0	0.5	1	1.5	2	2.5	3.5	5		
PROJECT RYLANDS BUILDING, MANCHESTER							SCALE 1:50@A0	DATE DEC 2023	
TITLE C29 PROPERTIES (MANCHESTER) LTD							JOB NO. 15626	DWG NO. AL(28)120	REV A
TITLE PROPOSED TYPICAL SOFFIT SCENARIO LEVEL 07 CUPOLAS							ISSUE FOR CONTRACT DOCUMENT

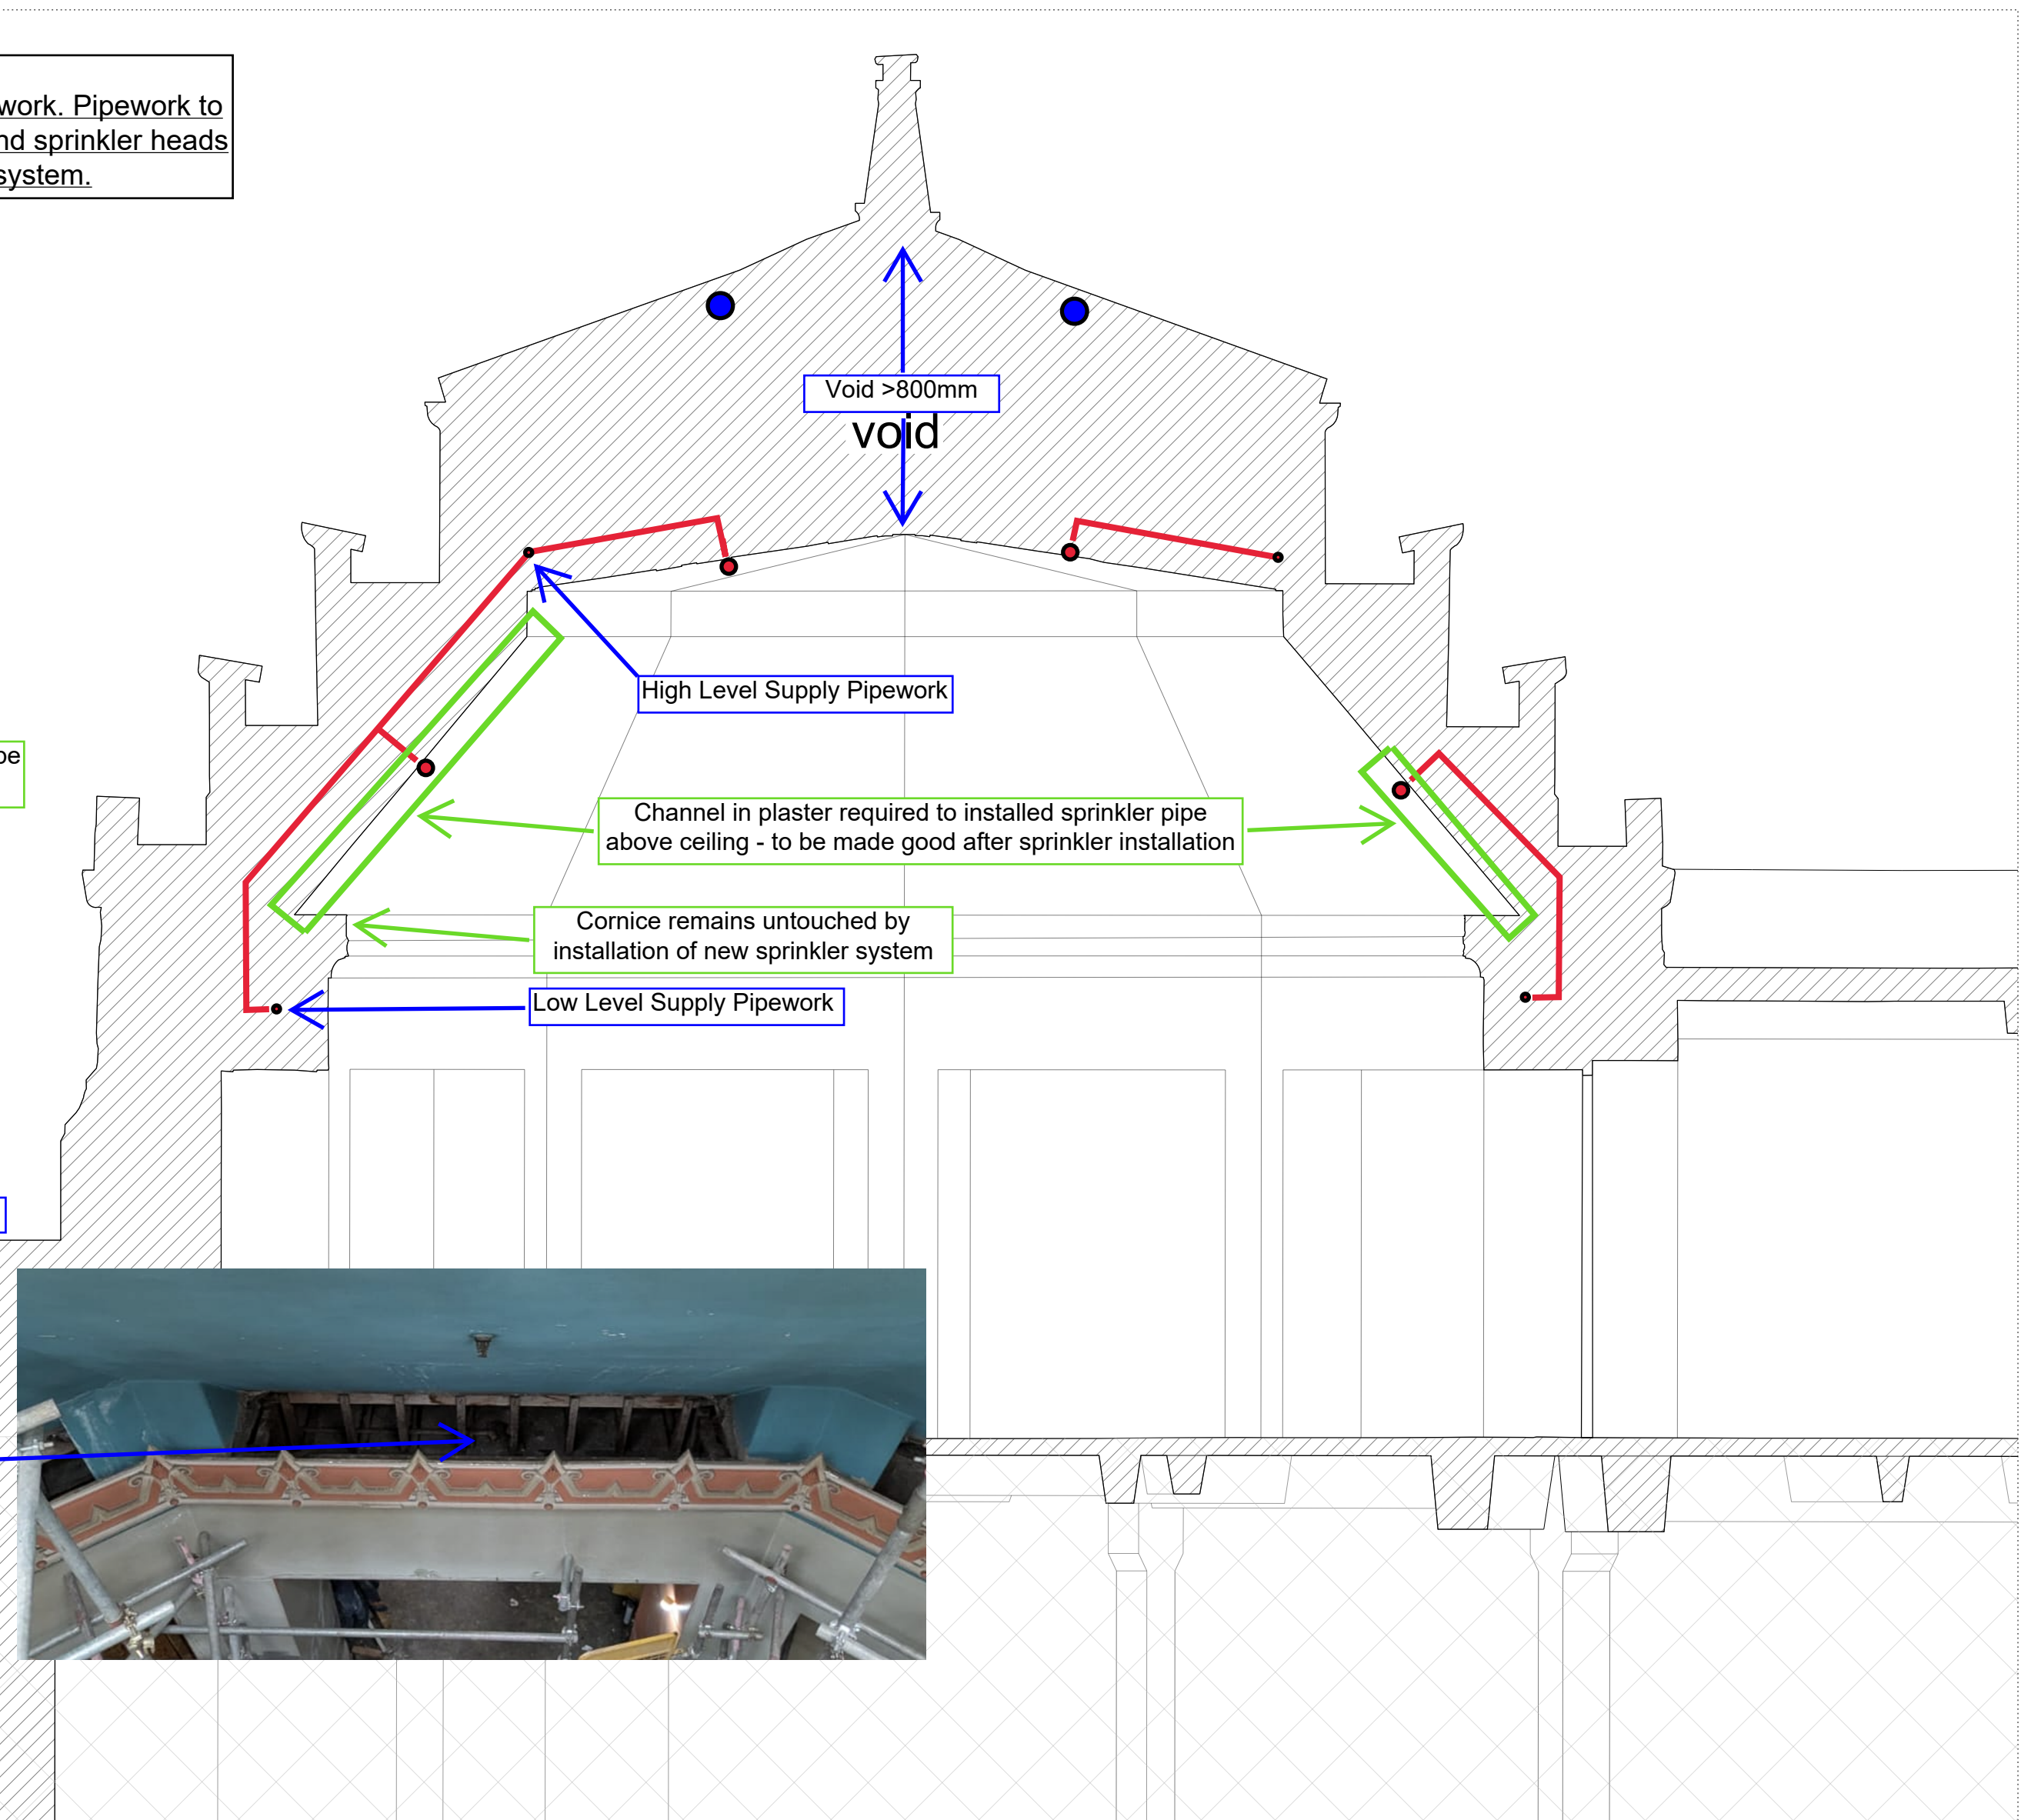
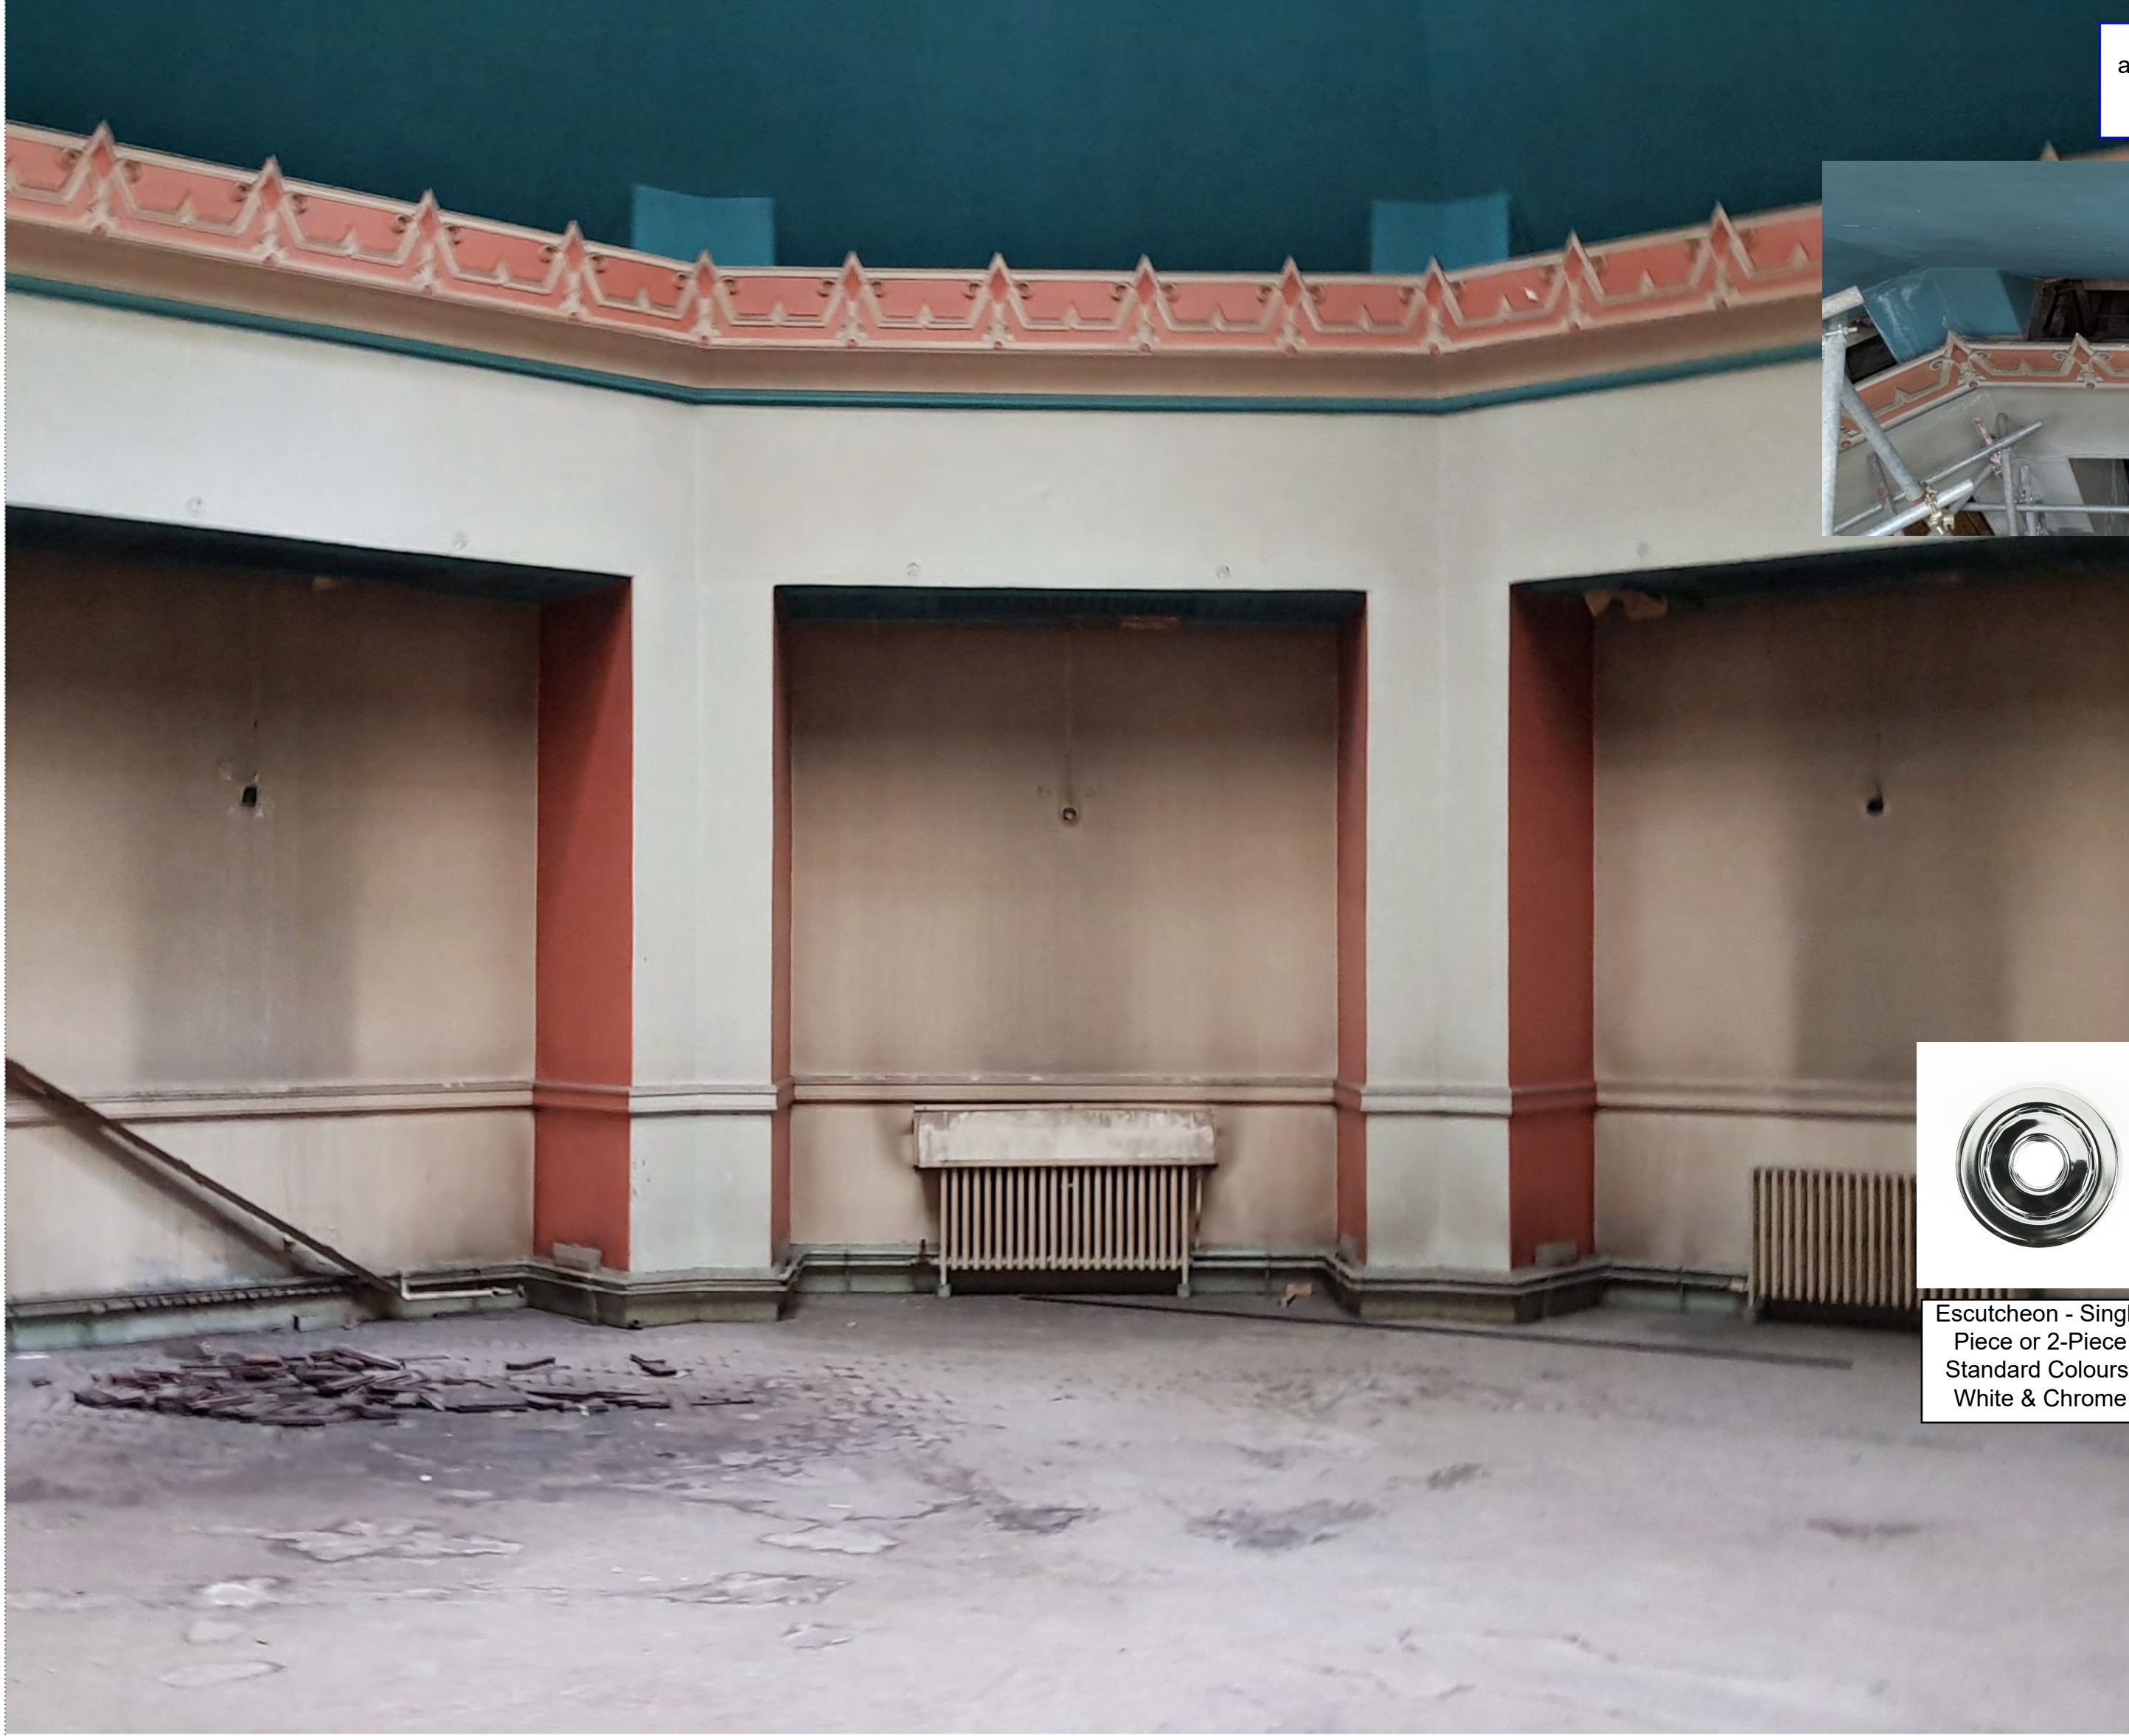
Cupola Sprinklers Option 1:
Replace old sprinkler system like-for-like with new sprinkler heads & pipework. Pipework to be concealed behind walls & ceiling as per the original sprinkler system and sprinkler heads located within the frame of the glass ceiling as per the original system.

GENERAL - Updates required to accord with updated Demolition & Encasement Removals AL(03)Series, and General Arrangement AL(04)Series.
